STAFF REPORT

Bluffs 9th Filing Summation

CASE NUMBER: Zone Chng-12-00016

Bluffs 9th Filing

Figure 1: PlanCheyenne future land use map illustrating collector streets with dashed lines.

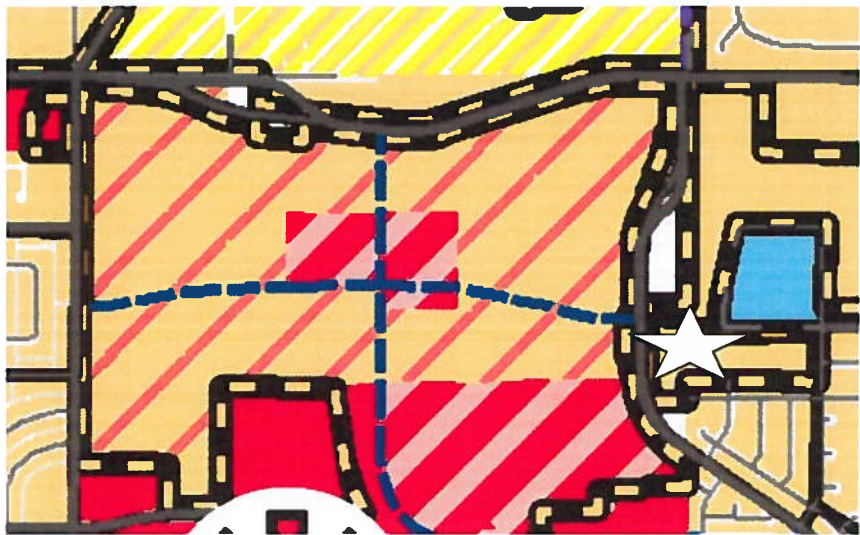
Relating to the transportation network system, PlanCheyenne lays out a basic street network with a collector type street bisecting Section 20 (see Figure 1) on the west side of Converse Avenue. On Figure 1 Converse Avenue is the north/south street west of the project area. The collector connects to the east with a four-way intersection on Converse Avenue at or near the project location. A purpose of a four way intersection is to have at least on connection between the two neighborhoods and to organize accesses to avoid unnecessary traffic conflicts. The vacant property to the north has already dedicated half of the street width in anticipation of this proposal submitting the same. The omission of any right-of-way along the north side of this plat is a significant deviation from the transportation master plan.

PlanCheyenne anticipates the growth of park and open space to be similar to or greater to what has been developed in the City in the past ((Foundation 6 – Creating a legacy of Parks, open spaces and trails). Viable open space is not proposed with this development.
